Please find below our response to your s92(1) request received 21 July 2022. For the sake of clarity, your questions have been transcribed across with our answers below. The memo is supported the following information:

Urban Design Assessment

BOUNDARY TREATMENT PLAN

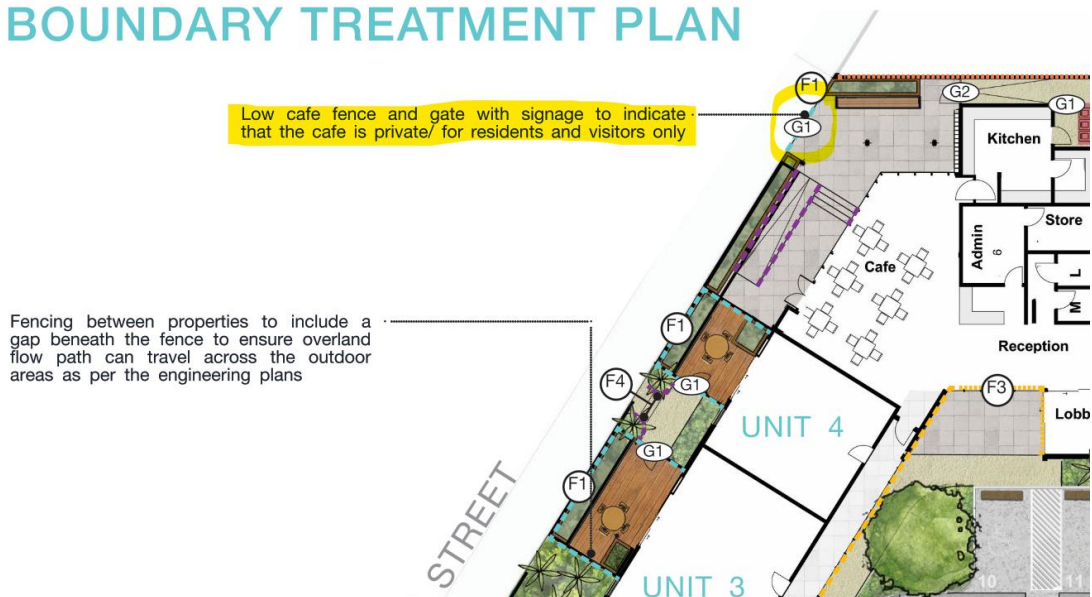
- 7) *Demonstrate how the café component does not have the appearance of being accessible to the public and use will be restricted to residents and visitors only and how any restrictions are able to be enforced. It is strongly recommended your design be amended so that the café has no direct access or visual commercial presence (i.e. frontage) when viewed from High Street. It is also recommend you consider*

nominating conditions that restrict use to residents and visitors similar to how club liquor licencing operates which require signing in for club members and their visitors (<https://resources.alcohol.org.nz/alcohol-management-laws/administering-alcohol-law/club-licence-licensing-manual/>). If the ultimate intent is to allow public access, provide an amended AEE that addresses the non-residential activity as a non-complying activity, and provide an economic assessment demonstrating the need for the café and how it won't detract from the economic vitality of existing commercially zoned land.

The above query runs counter to the pre-application urban design advice which highlighted the benefit of having an active street frontage. The café forms part of the common facilities onsite, which also includes the lounge and activity room, and, by virtue of being a commonly used facility, provides benefits of passive surveillance and activation at the street frontage.

As stated in the AEE, the café will be for residents and their guests only. There will be no signage specific to the café; the signage at this end of the building will denote the 'Ropata Village' branding only.

Furthermore, the applicant is proffering a condition that a low fence and entry gate be constructed along the boundary adjacent the café (see highlighted area in the image below) to better delineate that this is a private space. The fence and gate will be 1.2m high, semi-permeable fencing to match style F1 and G1 as per the landscaping plans. Should Council consider it necessary, a small sign could be attached to the gate stating 'Private – Residents and Guests only'. This has been included on the updated landscaping plans in **Appendix D**.
